## MEETING MINUTES

**SUBJECT:** RBRP JV-273: S.R. 2002, Section 000 over Reynolds Run Bridge Replacement Project, Little Britain Township, Lancaster County  
Consulting Party Meeting

## MEETING MINUTES

**SUBJECT:** RBRP JV-273: S.R. 2002, Section 000 over Reynolds Run Bridge Replacement Project , Little Britain Township, Lancaster County  
Consulting Party Meeting

EXHIBIT LAYOUT  
2 - 10' LANES, 2 - 2' SHOULDERS

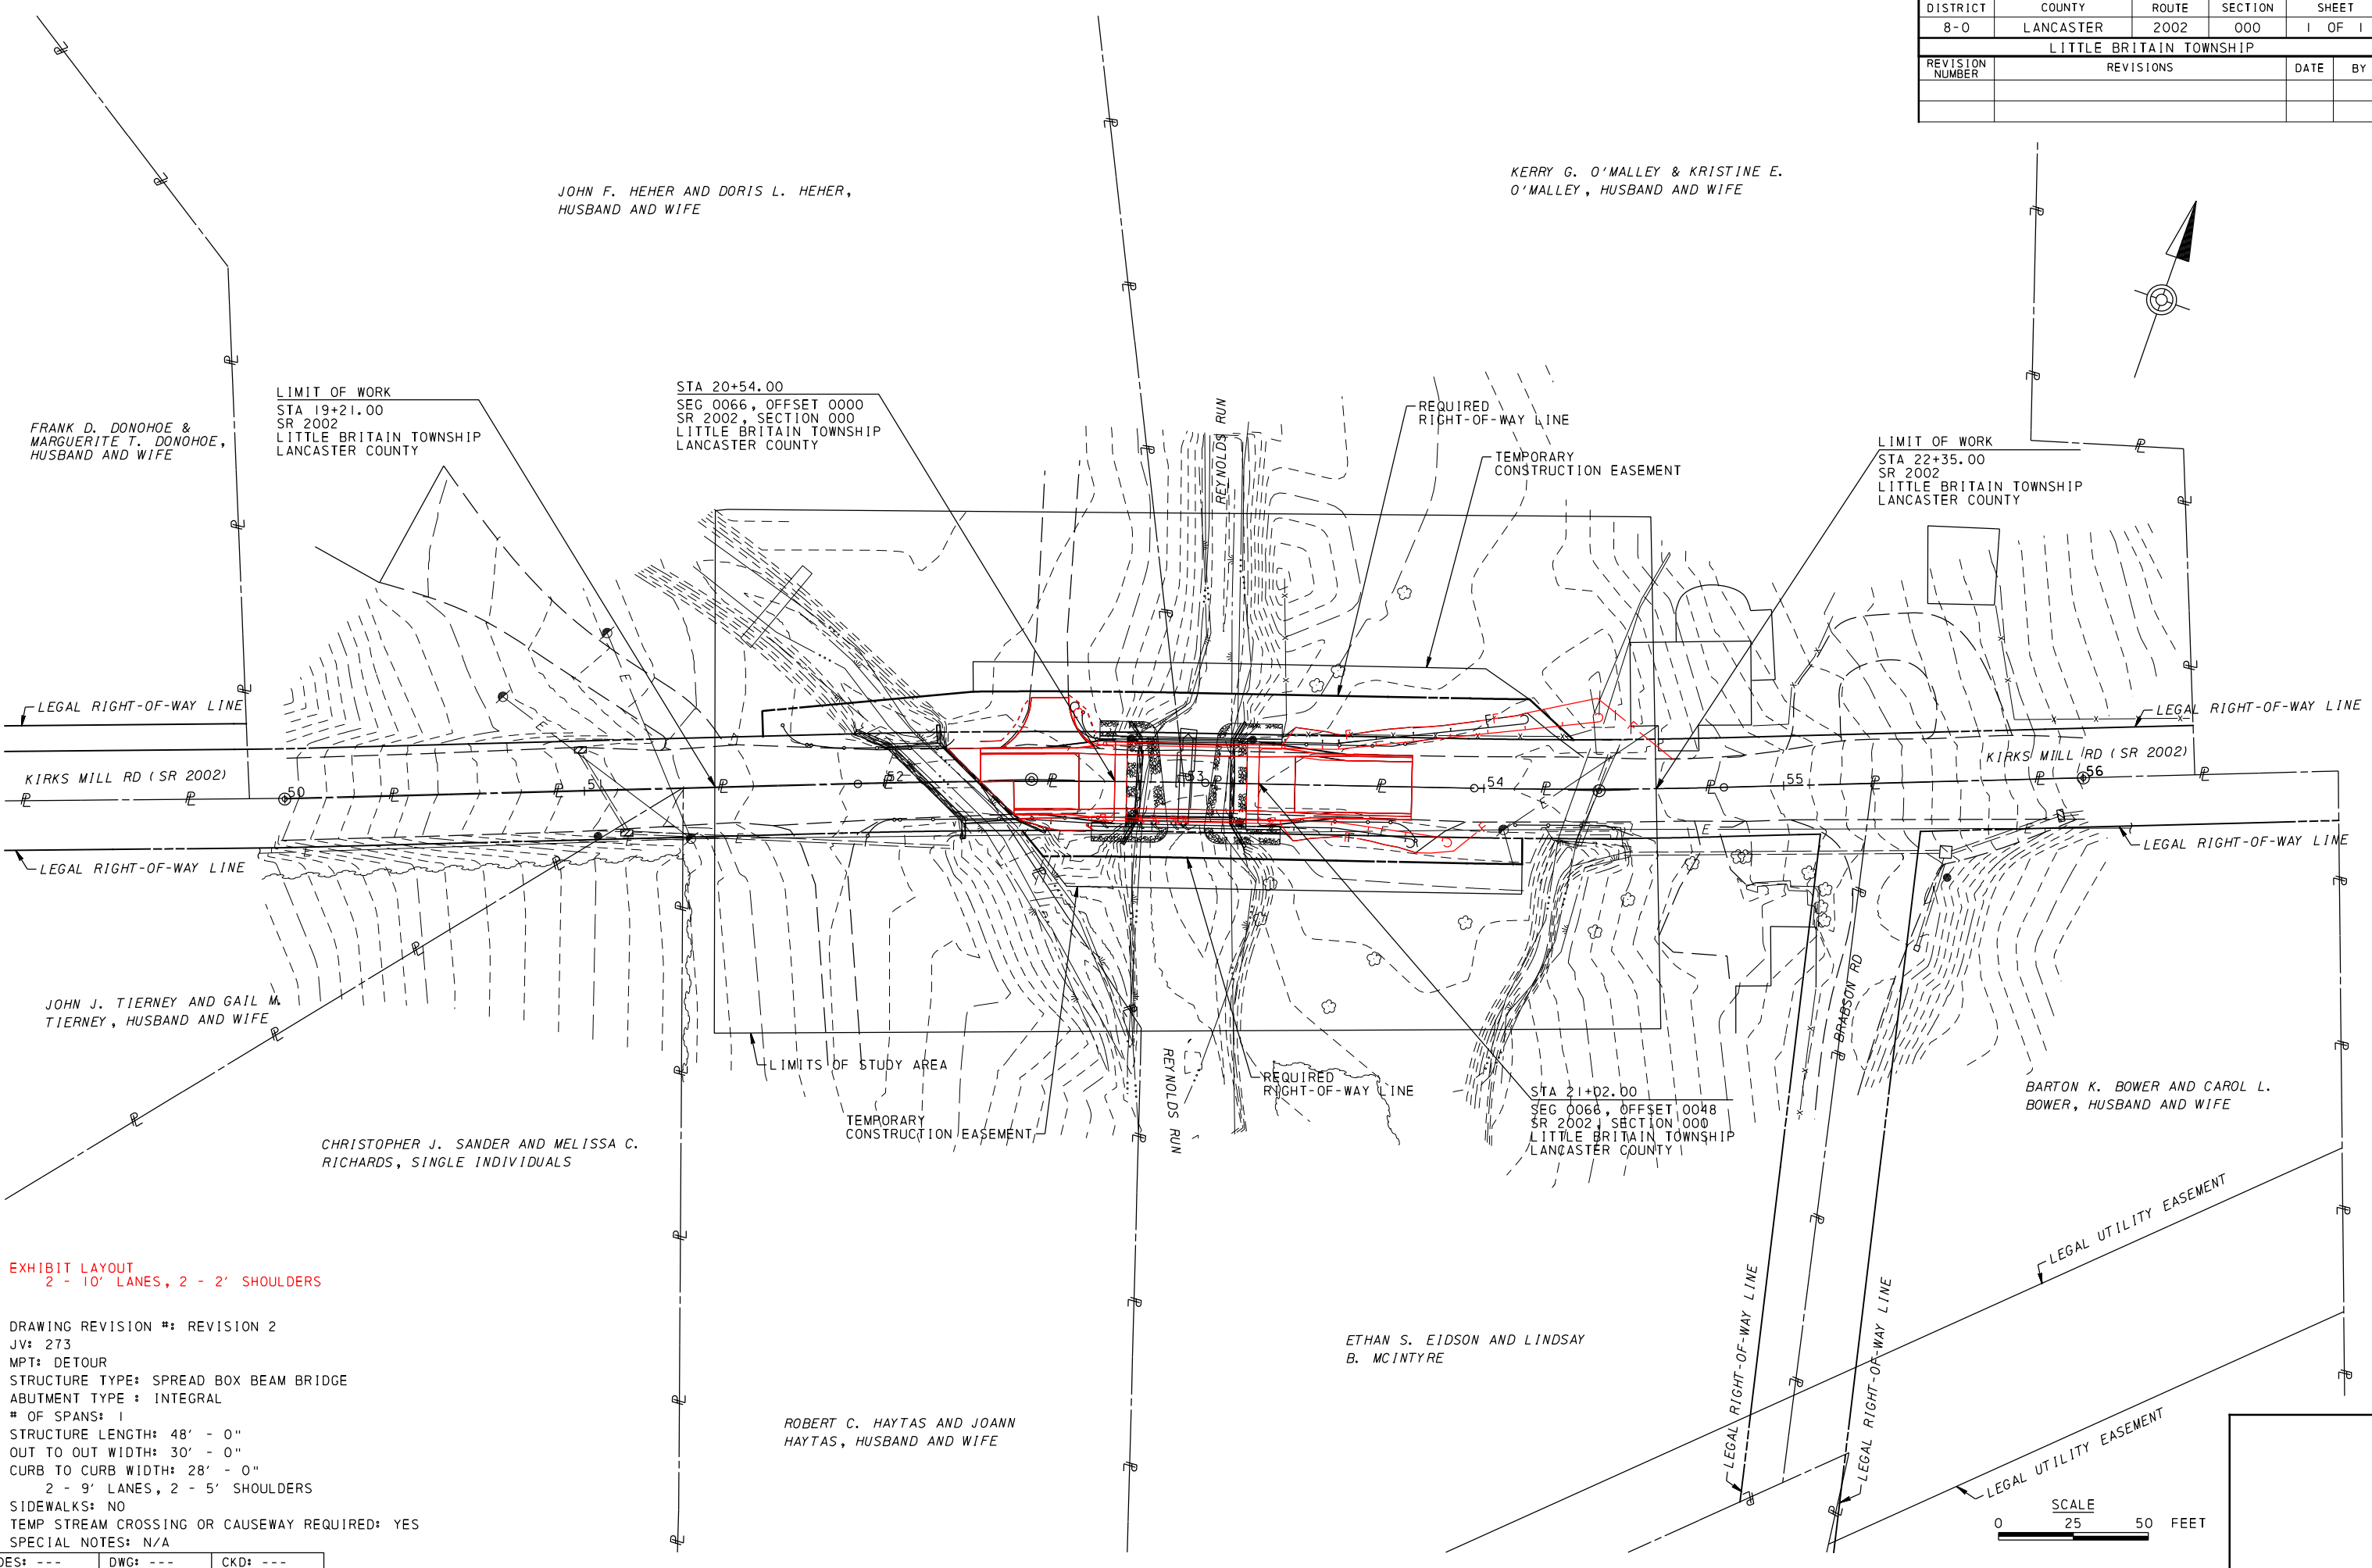
Plan Review: The plan reviewed at the meeting is attached. Following questions regarding the width of the bridge and the possibility of narrowing it, Ken Wright discussed a conceptual design option that decreased the curb-to-curb width of the bridge to approximately 24 feet. This option was developed in response to a question received during the March 22, 2016 public meeting asking whether additional right-of-way would be required if the bridge width was maintained at the current width. The design would require additional guiderail and right-of-way in the northeast quadrant within the O'Malley's Kirks Mill property. This option was deemed a poor alternative by the O'Malleys because of the proximity of the guiderail to the mill building and the need for additional right-of-way and additional fill on their property extending over the mill race.

**Tail Race:** The O'Malleys commented that the new plan shows a fill line into the tail race of the mill. As this is a conceptual plan, if the option was advanced, the final plan would show adjustments for the tail race to remain open.

**Contributing Property:** A question was asked regarding the absence of a contributing property on the plan in the northwest quadrant. Following the meeting, the plan preparer was contacted and stated that the building in that quadrant is not included on the plan because it is outside the study limits and outside the survey area. The property was reported in the Criteria of Effects Memo as a contributing resource and effects to the property were discussed. The building will not be physically affected by the project, but approximately 800 square feet of property will be acquired for placement of the new abutments, scour protection and guide rail.

Examples of Form Liners and Guide Rail for SR 2002 Reynolds Run Bridge Replacement Project Lancaster County

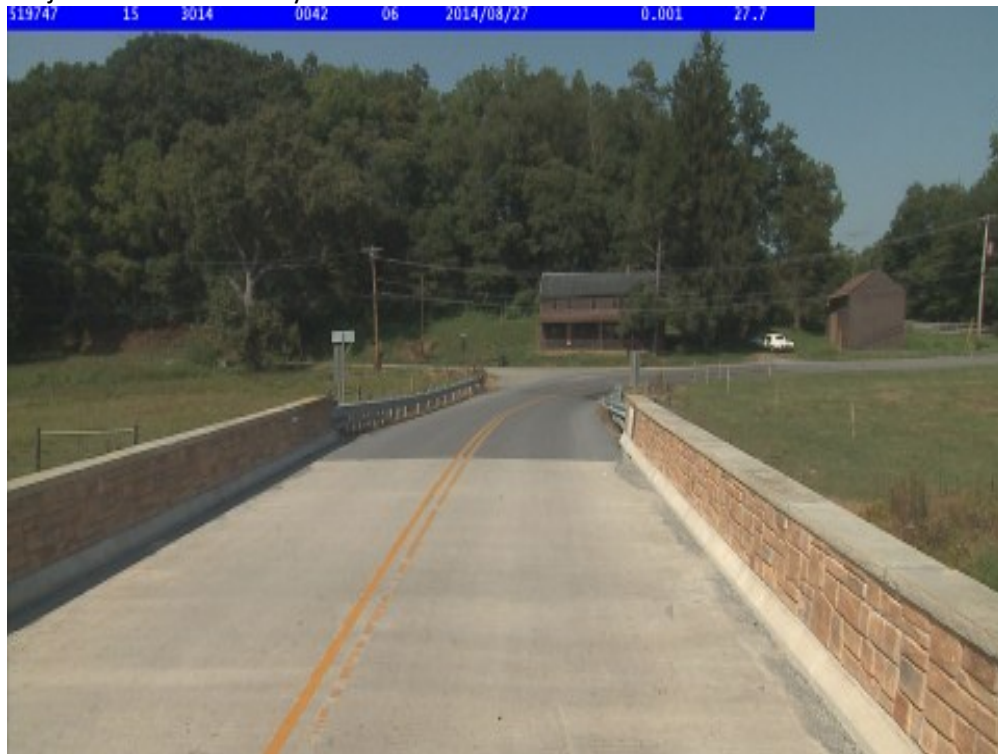
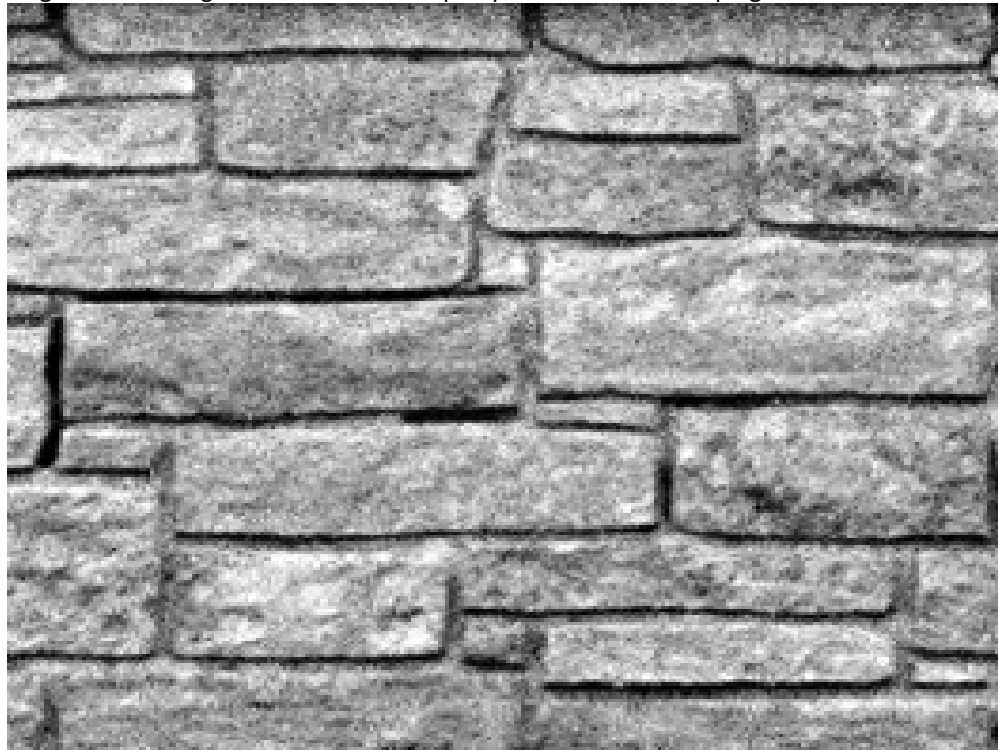
Aesthetic design: The use of a form liner for the exterior face of the parapet was proposed and documented in the minimization measures referenced above. Examples of patterns were provided at the meeting (attached). The stone pattern would be similar to the mill foundation. The concrete of the form liner, wingwalls and abutments will be tinted and in addition the exterior face of the parapet form liner will be stained to create an appearance similar to the mill foundation. At the time of construction, an onsite mock-up of the suggested treatment and colors will be provided. A request was made by the consulting parties to use the stone facing on the inside face of the parapet. Jim Bintrim agreed to determine whether that would meet PennDOT standards.

**Aesthetic Options:** At the request of the consulting parties, options for the aesthetic treatment of the bridge were discussed. It was their opinion that the proposed replacement concrete bridge would not blend with the historic district. Joanne Keim and Ken Wright provided examples of "stone" form liners from bridges located in Lancaster and Chester counties and a sample of the "stone" form liner. The bridge parapet treatment from the Chester County bridge was suggested by two of the consulting parties, the Bullitts and the Donohoes. Photos of the bridges are attached to the minutes. The consulting parties agreed that the use of a stone form liner would be a good option for the bridge aesthetic treatment. It would be more context sensitive to the surrounding historic district components as it would resemble the stone found on the mill building.

Meeting Follow-up: The use of a form liner on the inside of the parapet is not precluded by the Contract Documents and/or governing codes/specifications. Typically, the reveal on the inside of the parapet should be minimized to reduce the potential for snagging of errant vehicles with a 3/4" or less reveal being preferred.

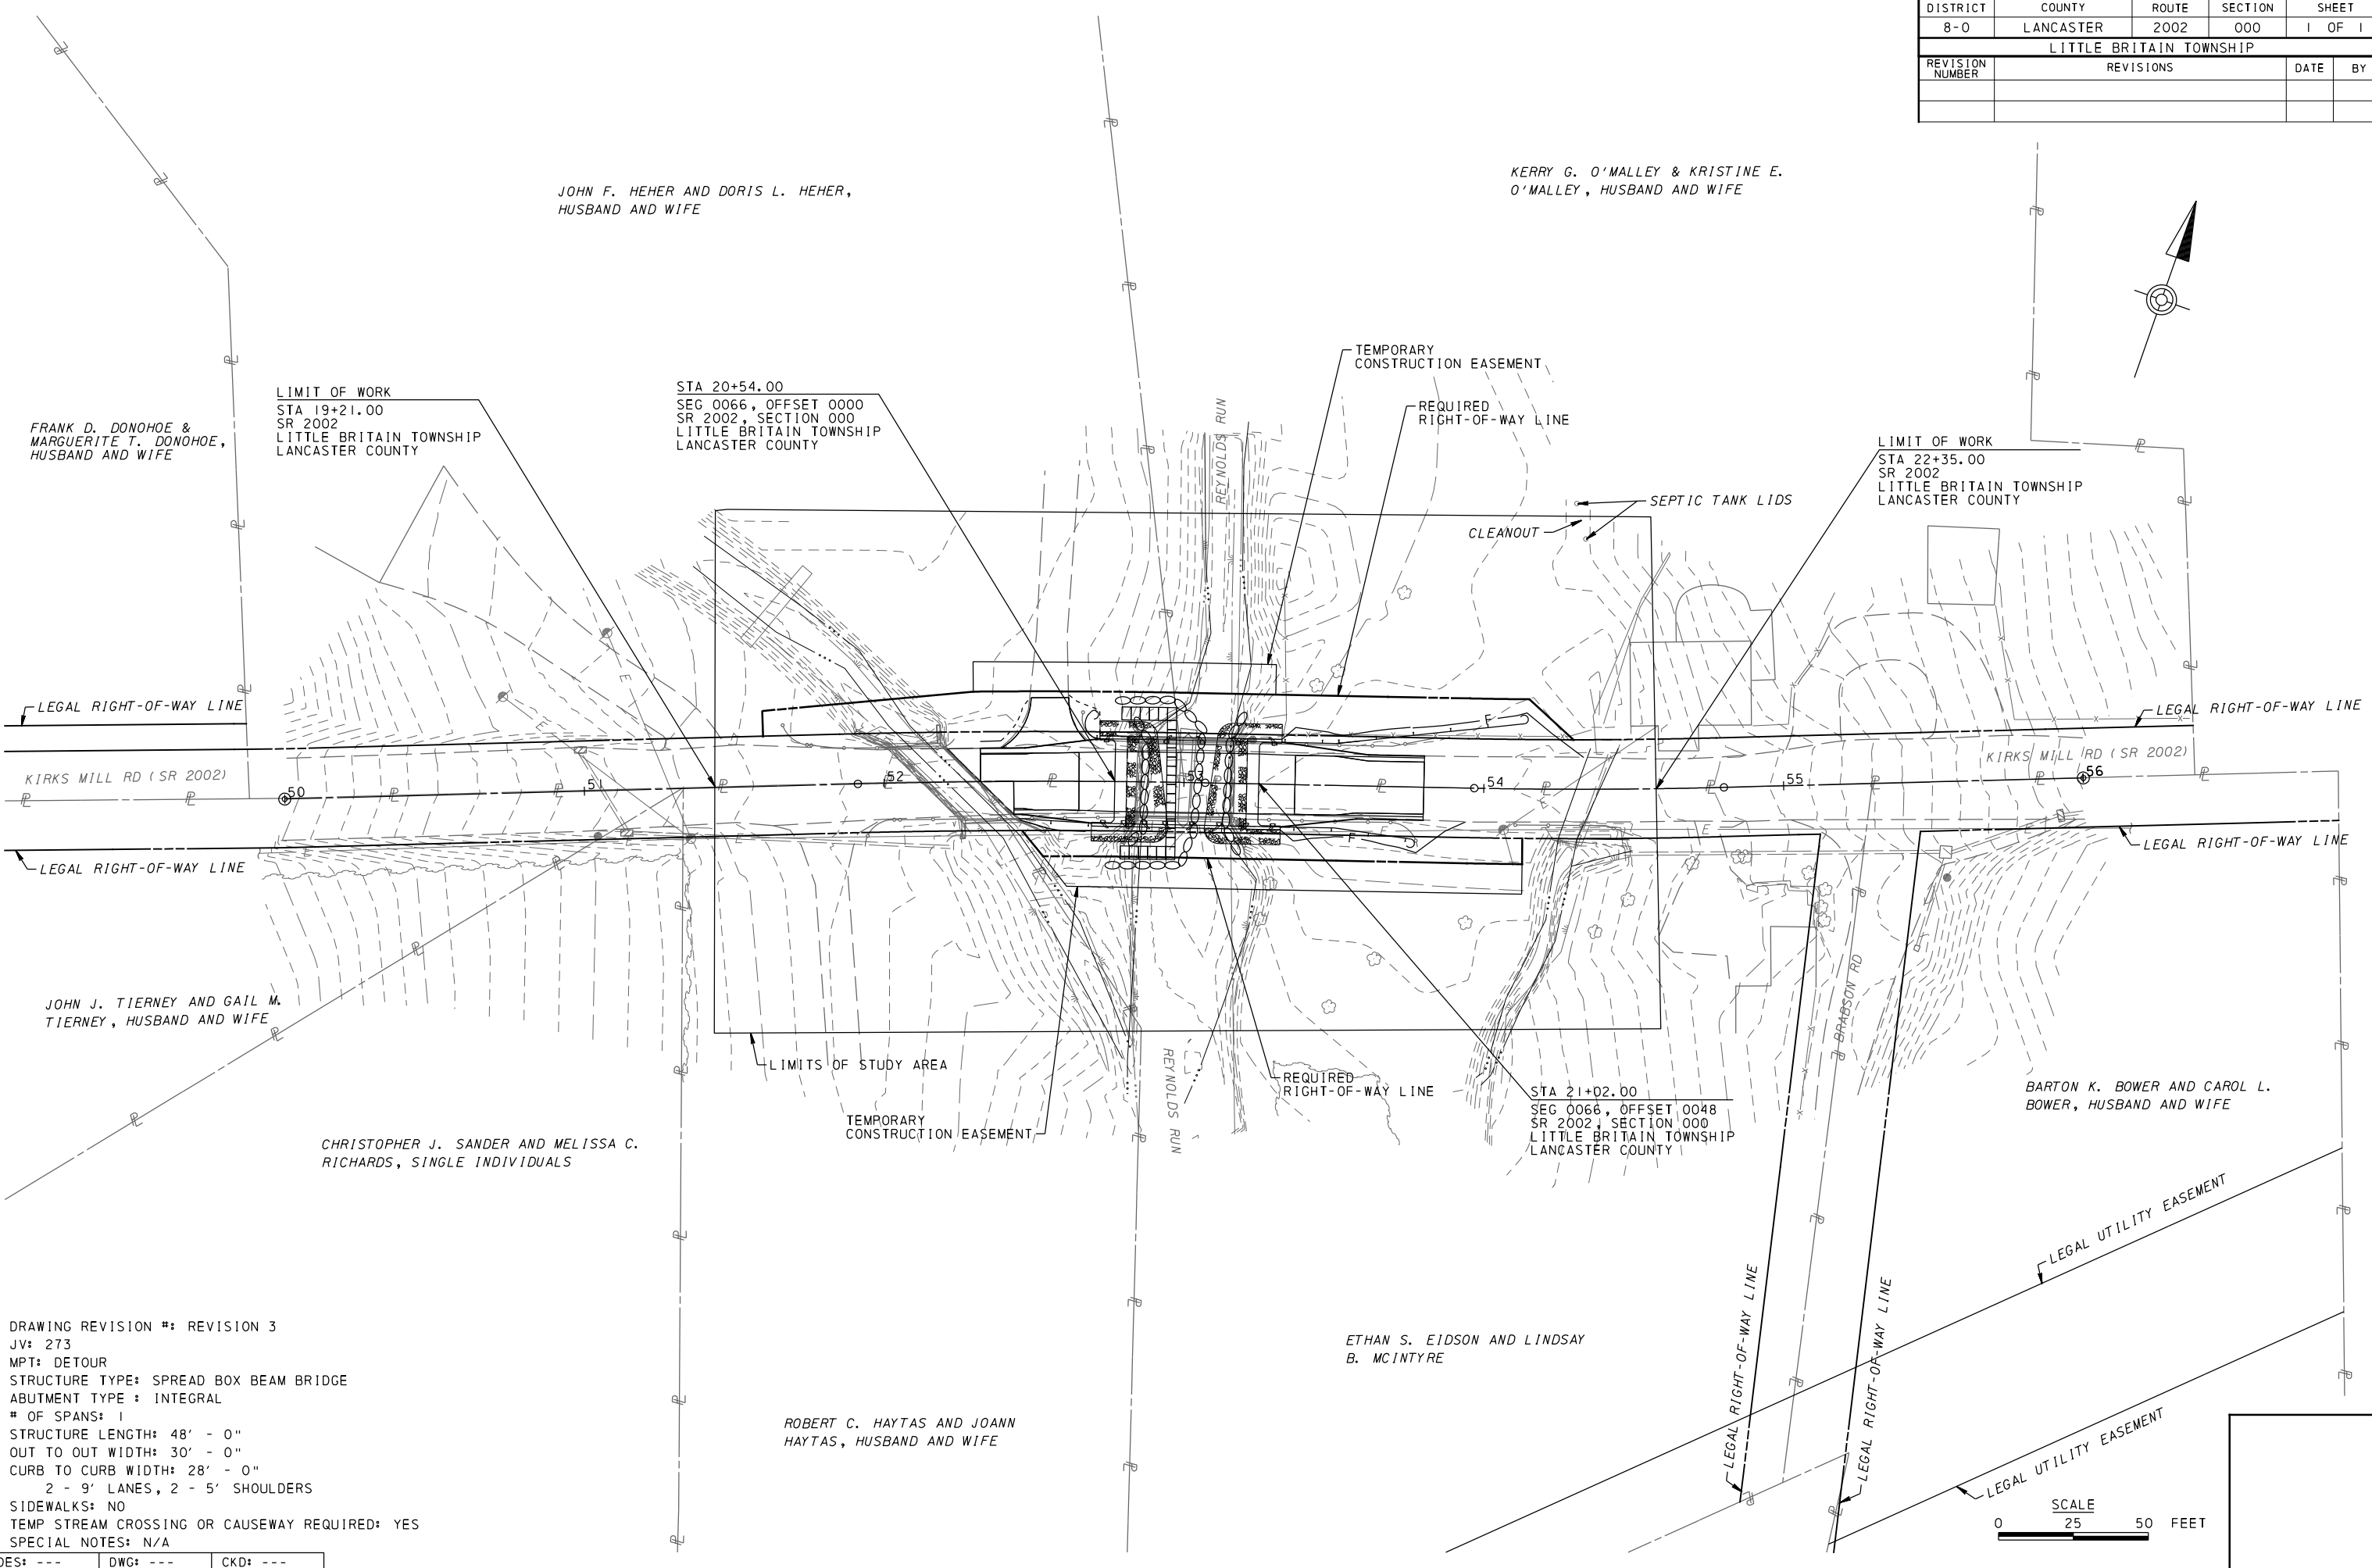
Locate Septic System: The septic system tanks and cleanout have been located and included on the project plan (attached). Through the use of ground penetrating radar, the septic field will be located and added to the plan. The property owner has been contacted to coordinate the completion of this task.
